Subject: RE: VHF radio communications assessment - Blackpool Airport

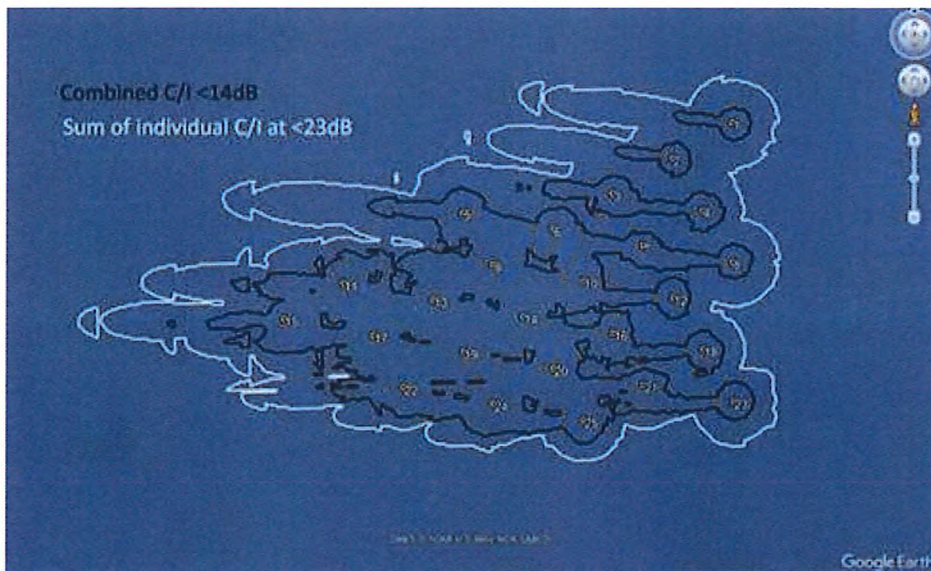
This however was not the only reason that I skipped over the combined turbine analysis in favour of treating each turbine as a stand-alone "worst single turbine interferer" at <23dB; It is the case for turbine as far apart as these that the individual impact dominates (see below the 500ft case and attached to show the trend gets more pronounced as altitude increases) and therefore it is erring on the side of caution when checking 169 turbines against 12 different radio stations to assume each turbine has their own volume of interference based on the worst case CAP670 criteria and select a few representative samples for analysis.

If Blackpool assume that radio performance will be sub-optimal within the volumes identified in the report (assuming that every turbine has a similar volume around it, which would merge at 500ft and 1000ft to encompass the complete farm, breaking down into pockets of interference at high altitudes)

they should hopefully be able to provide a statement as to how operationally significant this would be. If they can live with this worst case then we can put this to bed, if not we can look at some additional modelling for specific areas and radios before moving on to discuss mitigation.
